Meeting Agenda

Franklin Municipal Planning Commission

Thursday, January 25, 2024

TUCK AWAY PUD SUBDIVISION VESTING EXTENSION REQUEST RESOLUTION 2023-81

TYPICAL SECTION (Roads A & B)
BASED ON COF STD, DWG, TS-6 (Low Volume Local)

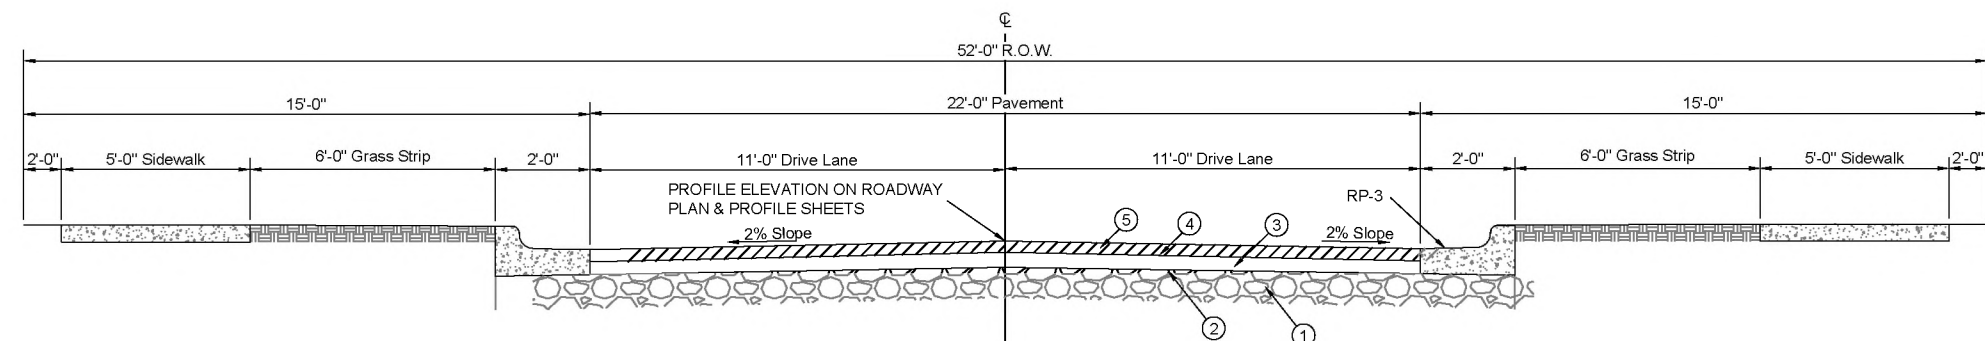
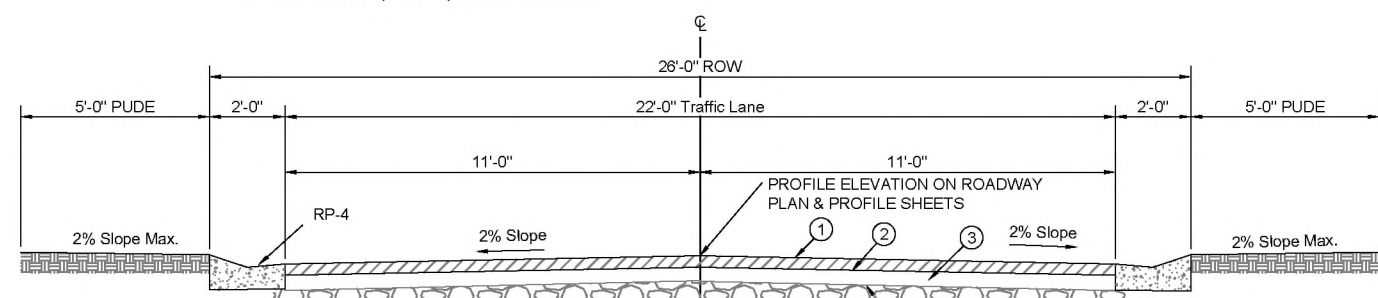
Applicant shall revise the local street sections to match COF Standard Drawing TS-6, including providing a 6'-0" wide grass strip and 2'-0" grass strip beyond the sidewalk.

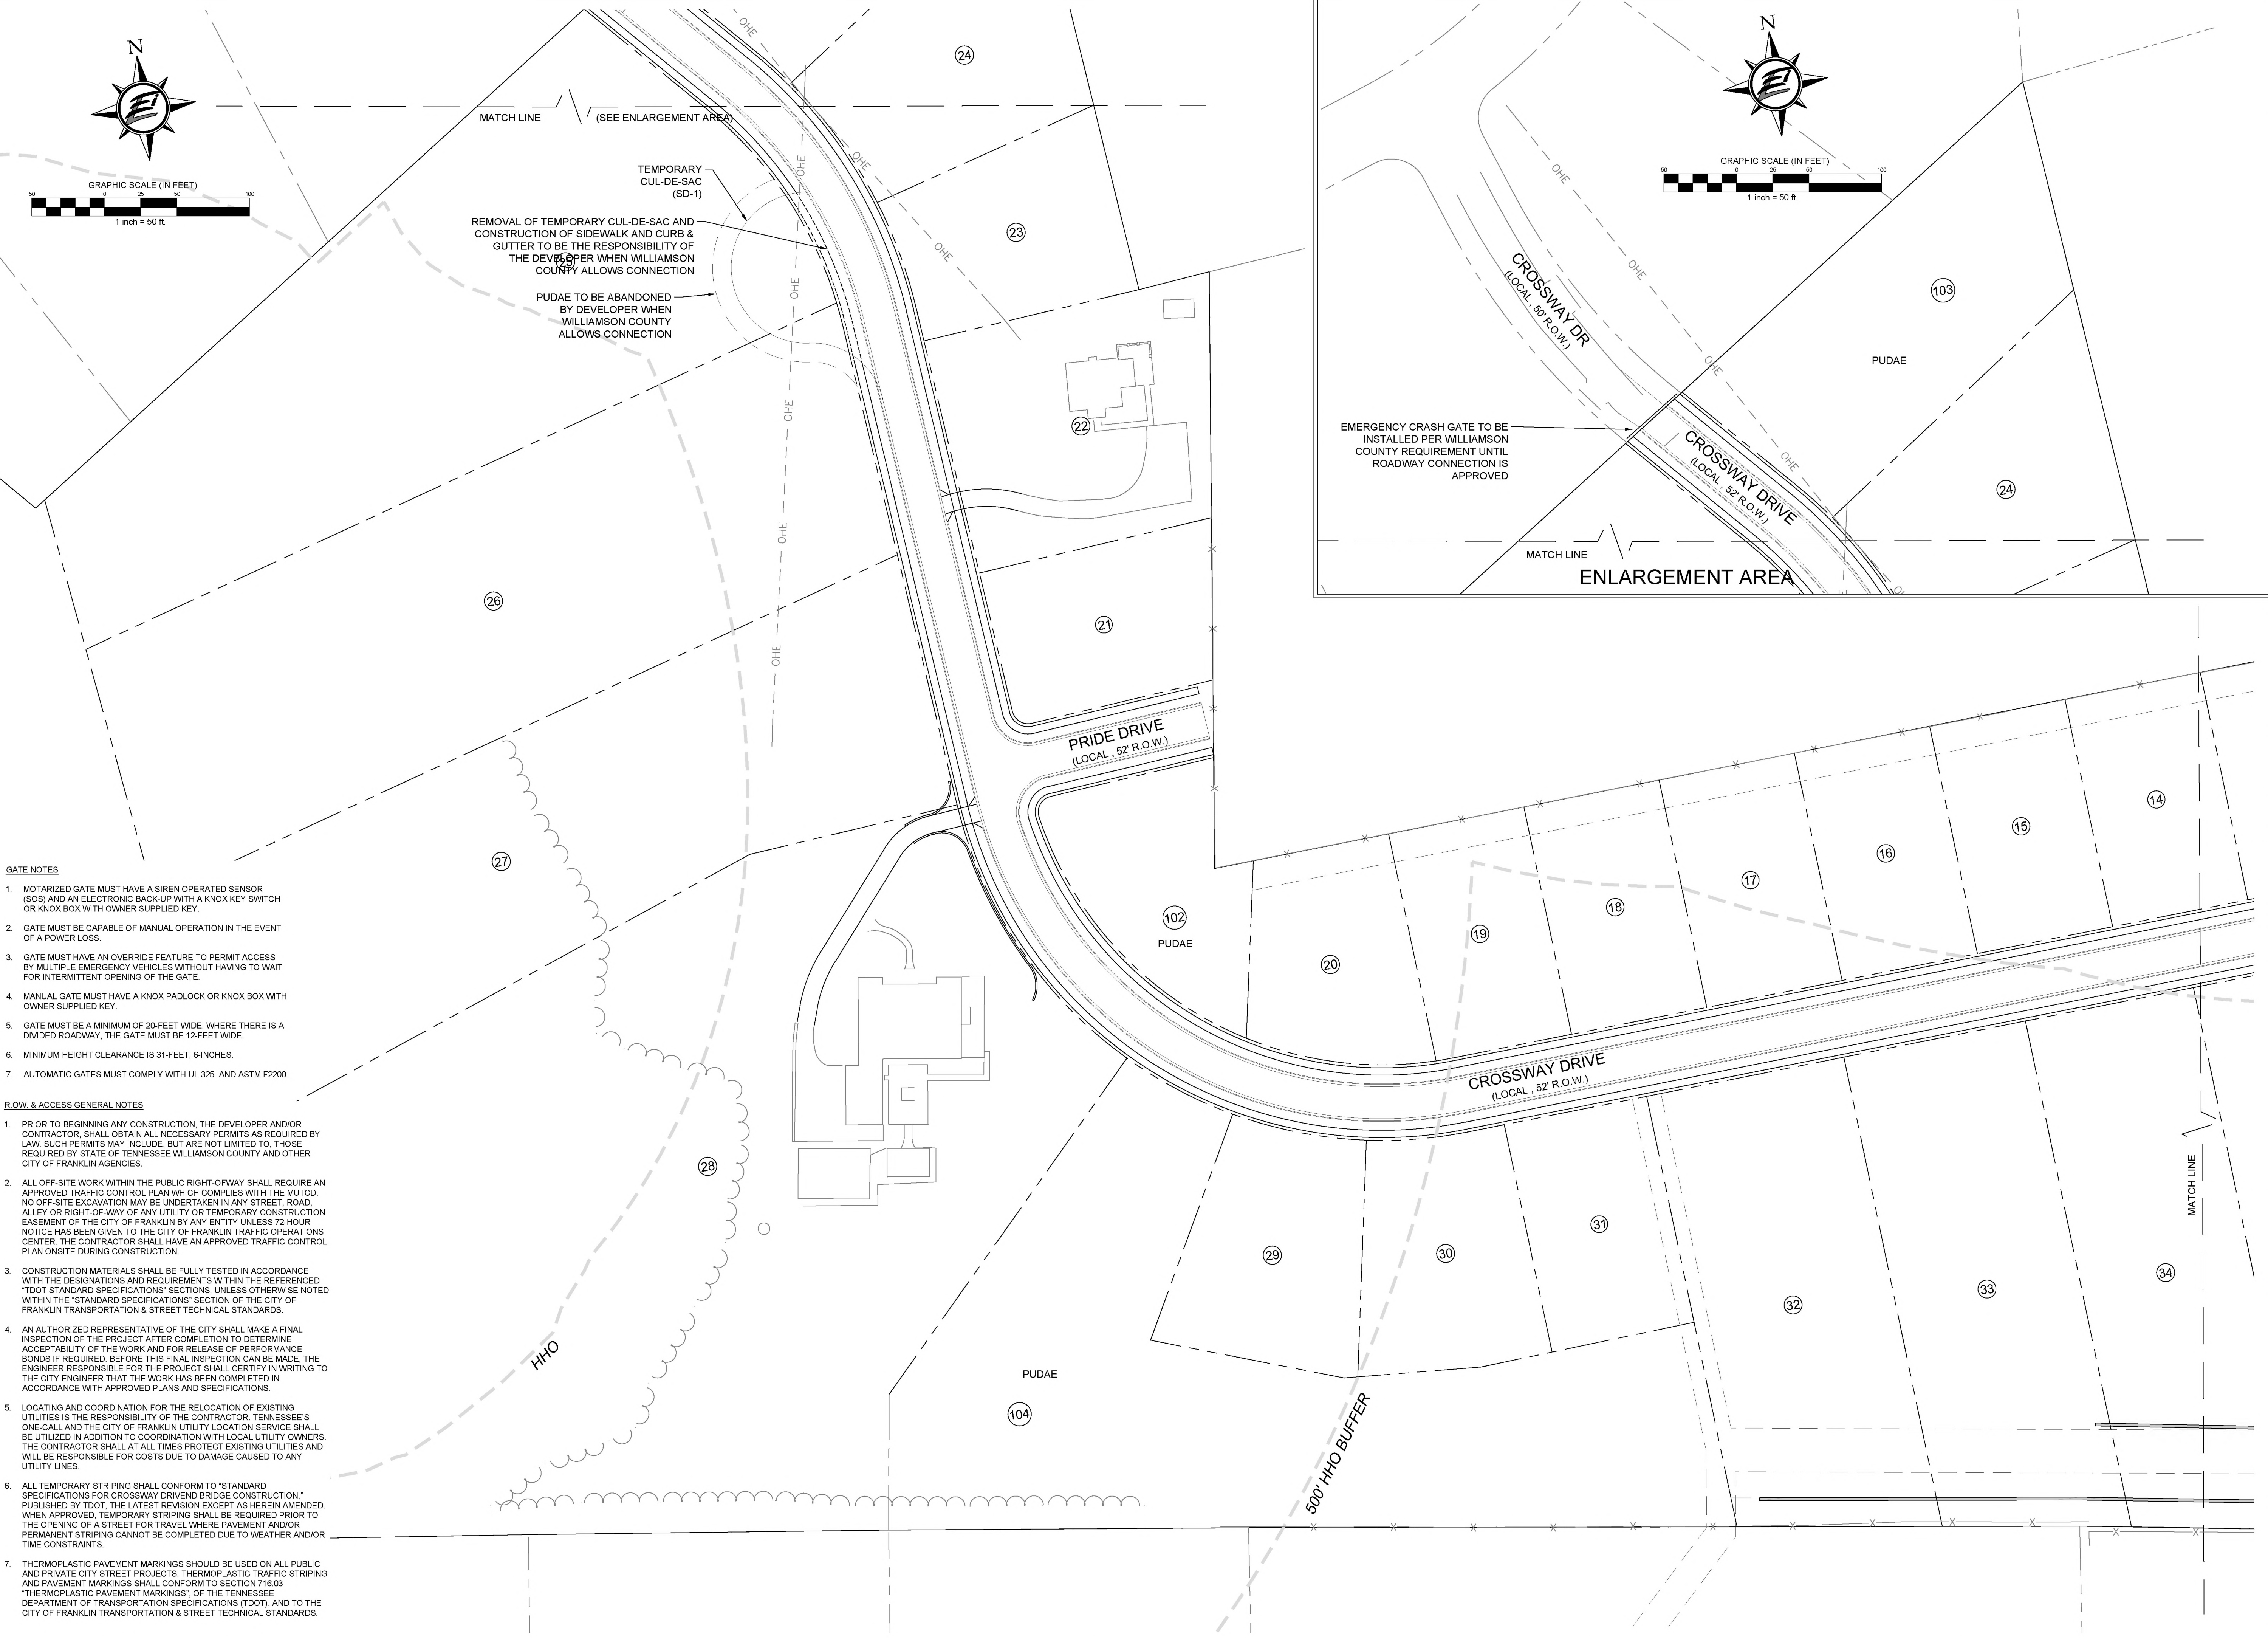
curt.edelmann@franklintn.gov It appears that a gate has been added to Sheet C4.3. The fire department will not address whether or not a gate is permitted. In general, the fire department discourages the use of gates because it slows emergency response. If a gate is approved, the following requirements must be met.
